Determination 2012/054

Regarding the refusal to issue an amendment to a building consent for a 3-year-old conservatory addition to a house at 14 Byron Street, Rolleston

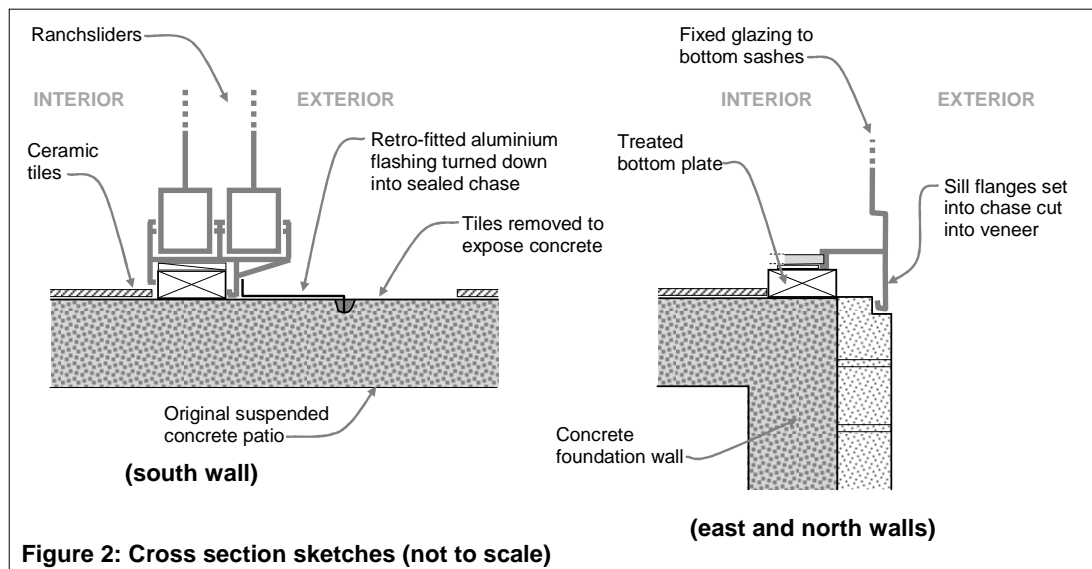
- 5.3.2 At corner posts, jamb flanges overlap the folded corner flashings, with a sealant fillet at the junction. The expert pressed against the flashing, noting that sealant was not bonded to the metal. At the bottom of the north and east walls, sill flanges are set into a rebate cut into the block veneer, with a cover of about 20mm (see Figure 2).

- 5.3.3 The south wall sits on the original concrete surface and an aluminium flashing is retrofitted over the concrete at the sill, with a 12mm upstand and the outer edge turned down and sealed into a narrow chase. The exposed concrete is currently lower than the adjacent path tiles and veneer lip, with water able to pond in the recess. The intention is apparently to reinstate the tiles that were removed to install the flashing.

6.2.2 The authority has refused to issue an amendment to the consent, and maintains that the as-built details as shown in Figure 2 have the 'potential to trap moisture in aluminium frame and bottom plate' and the amended drawing does not accurately reflect actual construction.

- the intention to reinstate the removed tiles will result in the aluminium flashing terminating below the tile surface and coming into contact with tile cement grout, with premature deterioration due to incompatibility⁶

- the exposed recessed concrete impedes drainage and is currently ponding adjacent to the ranchslider flashing. Run-off from the grout to the exterior tiling will also lead to premature deterioration⁷.
